STAFF REPORT

TO: Mayor and City Council
FROM: Ken Roberts, Planning Director
AGENDA ITEM: Union Park Second Addition Final Plat
REVIEWED BY: Jack Griffin, City Engineer

Pulte Homes of Minnesota (Pulte) is requesting City approval of the Final Plat to create lots for 71 townhomes located on 8.61 acres. This proposed final plat is the second phase of a 240 townhouse residential development that is part of a 72.60 acre final plat known as Union Park.

File: City of Lake Elmo Landscape Plan Review
Union Village 2nd Phase, Review #1

LANDSCAPING PLAN

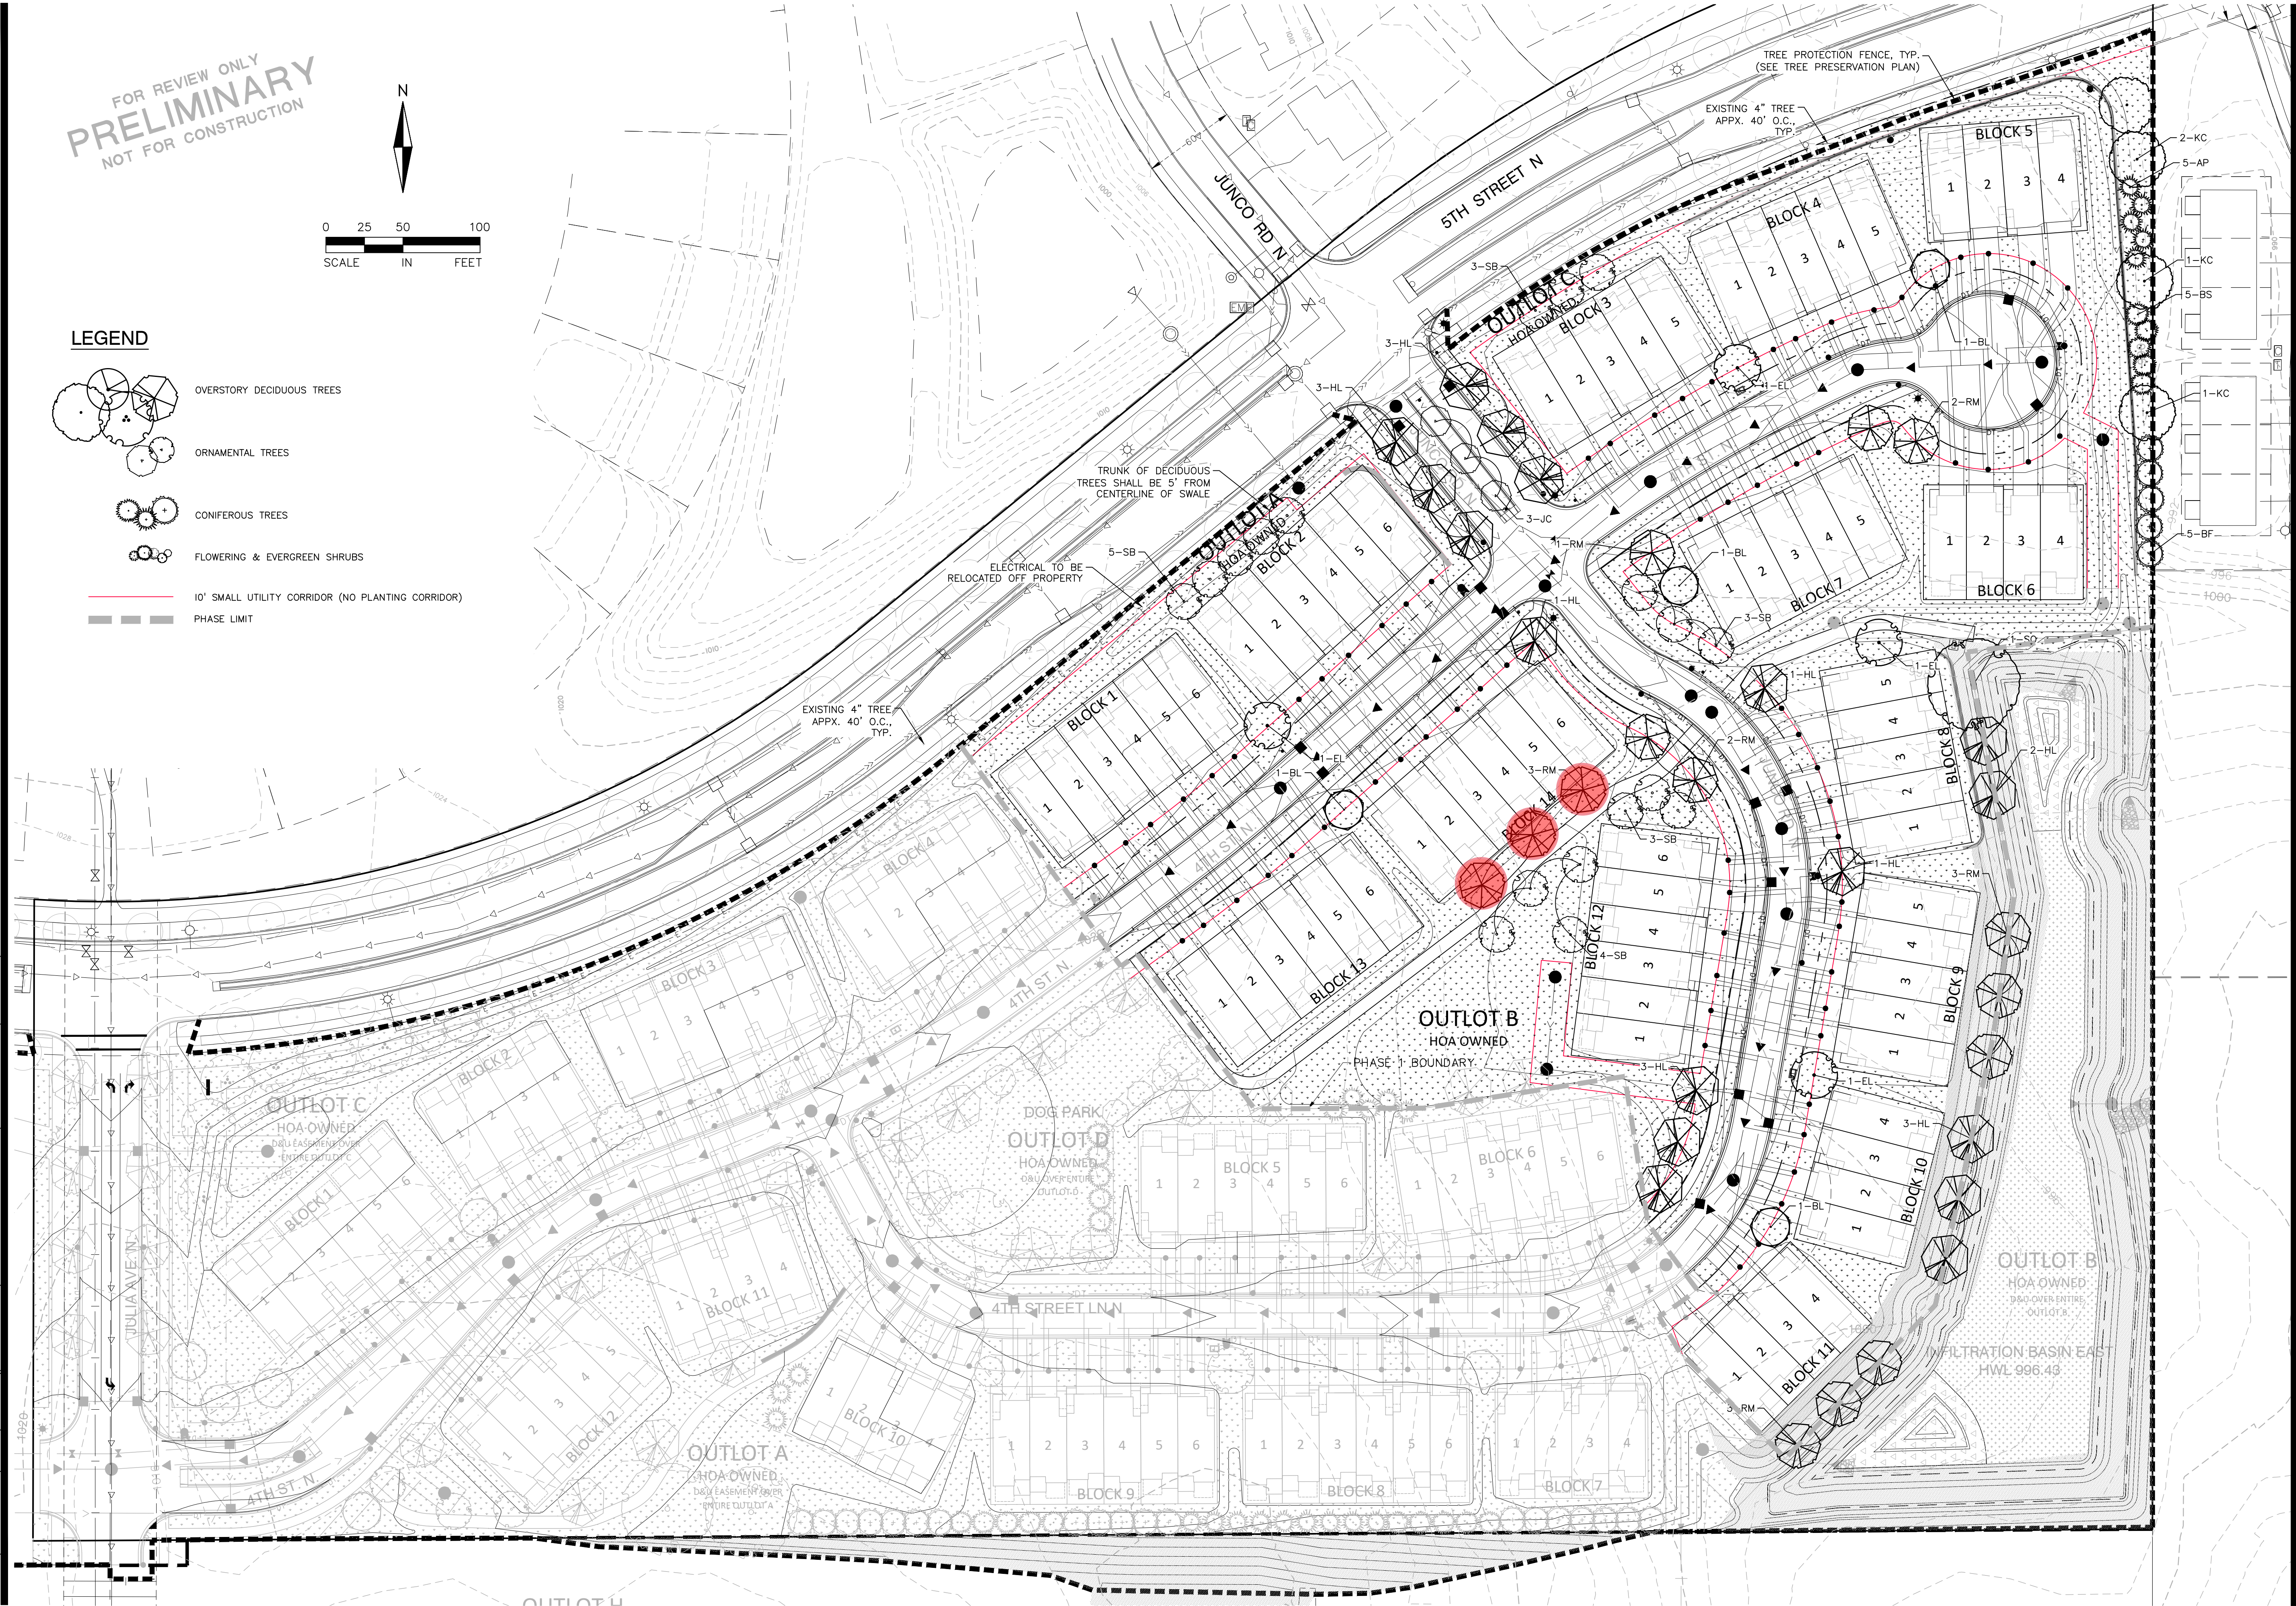
- 1. The submitted landscape plan shows 3 trees that conflict with the Block 14 townhomes. These trees are proposed to be planted less than 10 feet away from this building and will cause future conflict. These trees, shown on the attached figure, will need to be relocated.

- 1. Submit a revised landscape plan.
